**REPORT TO DESIGN REVIEW BOARD**

**SUBJECT: 16 De Luca Place** - Request for Conceptual Design Review to demolish an existing one-story industrial building and construct a new two-story, 7,774 square foot building. The building will contain primarily storage/factory spaces with ancillary office space not exceeding 25 percent of the overall building square footage.; APN: 013-081-04; Industrial (I), Zoning District; Mark and Kathleen Barger, Owner; Stewart Summers, SKS Architects, Applicant; File No.: CDR21-001

NEW SITE PLAN  
SCALE: 1" = 12'  
0' 3' 6' 12' 24' 48'

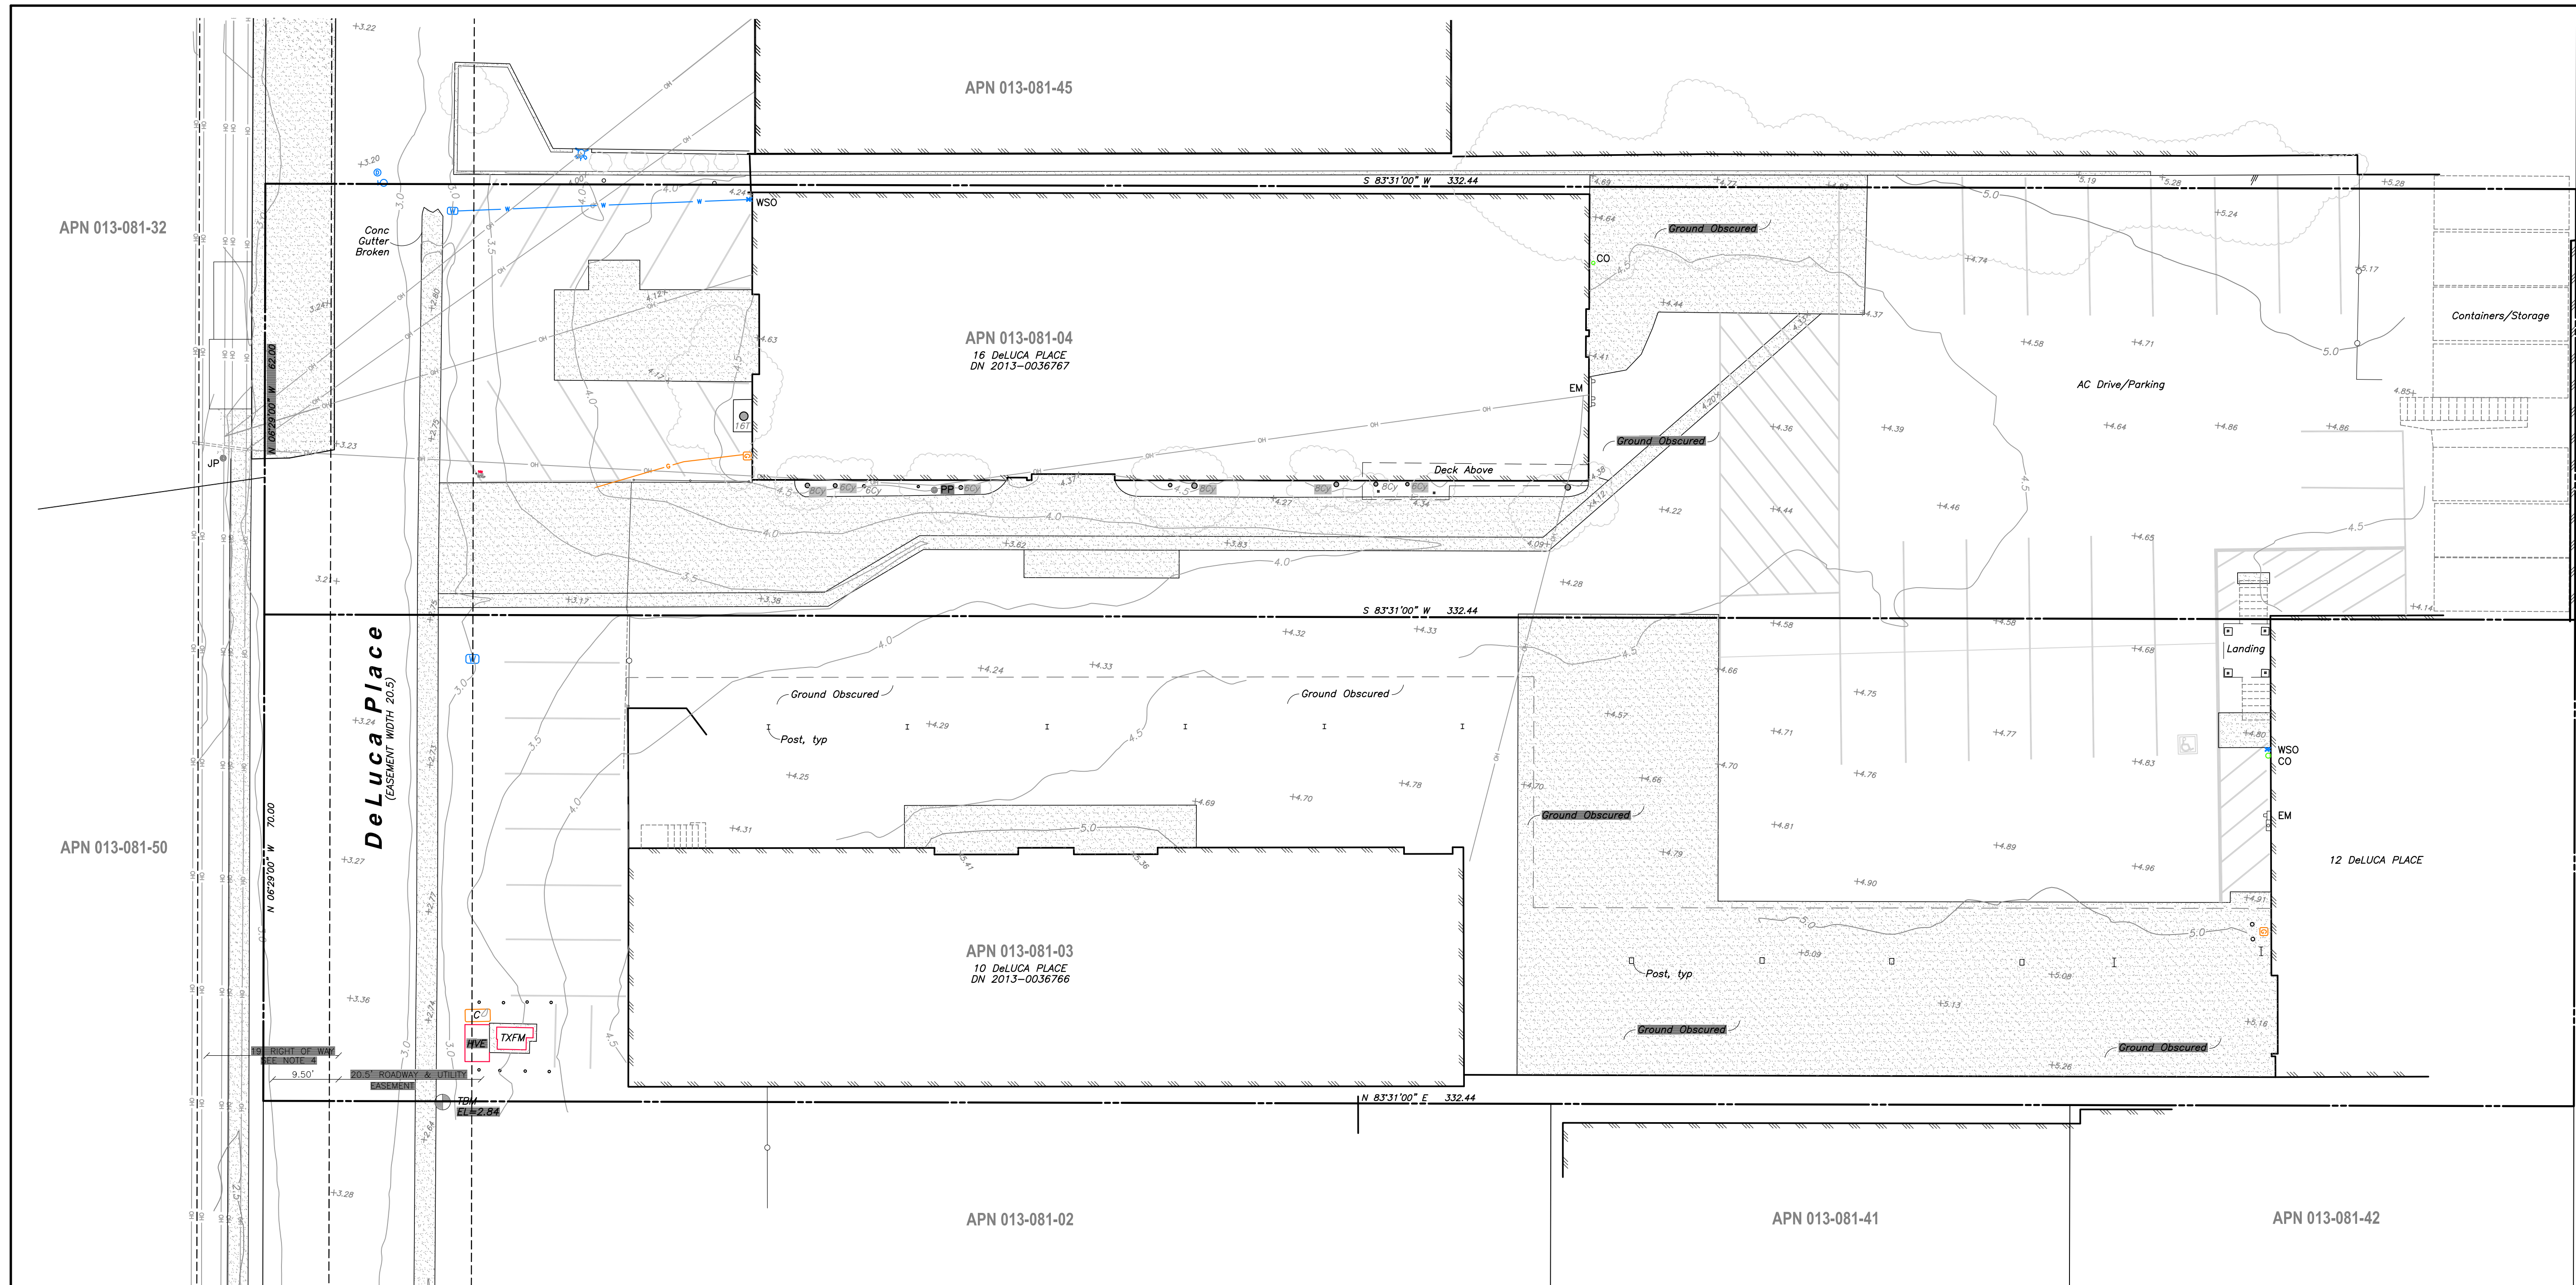
The Industrial Zoning District requires a minimum landscaped area of 10% of the project site, which is equivalent to 2,061 square feet for the project. Plans submitted for conceptual review are inconsistent with this requirement as the total landscaped area provided is 866 square feet (excluding the vertical landscape feature), which equates to 4.2% of the total site. Staff is seeking feedback from the Board relative to the placement, type, and size of proposed landscaping as well as recommendations for modifications to the site design that will accommodate an increase to the landscaped area in order to meet the minimum requirements, as appropriate.

Pursuant to Section 14.16.025 of the SRMC, the proposed project will be required upon formal submittal to provide an area on-site suitable for collection of trash and recyclable materials. Plans submitted for conceptual design review indicate that a 10-foot x 12-foot covered refuse enclosure will be located at the northeast corner of the site. As noted in comments provided by Marin Sanitary Service on the proposed project, the enclosure will need to be enlarged to accommodate an 18-yard bin which measures 13-feet x 9-feet.

As proposed, non-compact parking stalls do not meet the minimum length requirements set forth in Section 14.18.130 of the SRMC. Specifically, the SRMC requires non-compact parking stalls to measure 9-feet wide by 19-feet long. As proposed, the non-compact parking spaces measure 9-feet wide by 18-feet long. Additionally, the minimum required drive aisle width is 26-feet whereas the project proposes 25-feet 6-inches.

As proposed, the project will install an 8-foot in-swing gate between the proposed building and the northern property line. Material details of the gate are not provided. Staff is seeking the Board's feedback and recommendations on the location and design of the proposed gate.

ALLIED HEATING AND A.C. COMPANY, INC.  
**LANDSCAPE PLAN**  
16 DE LUCA PLACE  
SAN RAFAEL, CA 94901

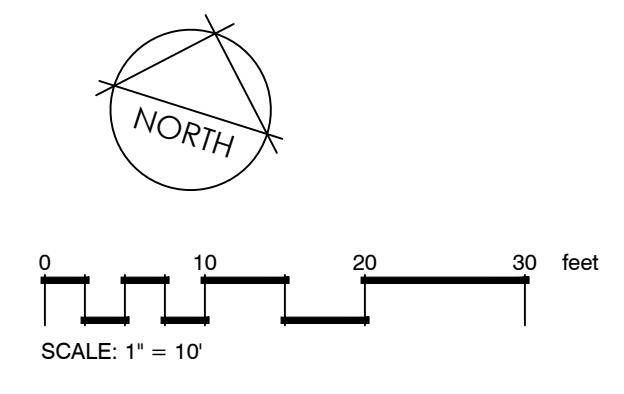
**Landscaping:** As shown on the preliminary landscape plan submitted with the Conceptual Design Review application, the project proposes to install landscaping along the north, east, and west property lines and will include trees, shrubs, and groundcovers. Additionally, the project proposes to install vertical landscaping at the southwest corner of the new building. The project proposes a total of 866 square feet of landscaping, excluding the vertical landscape wall. As proposed, the landscaping does not meet the minimum 10% required by the zoning ordinance.
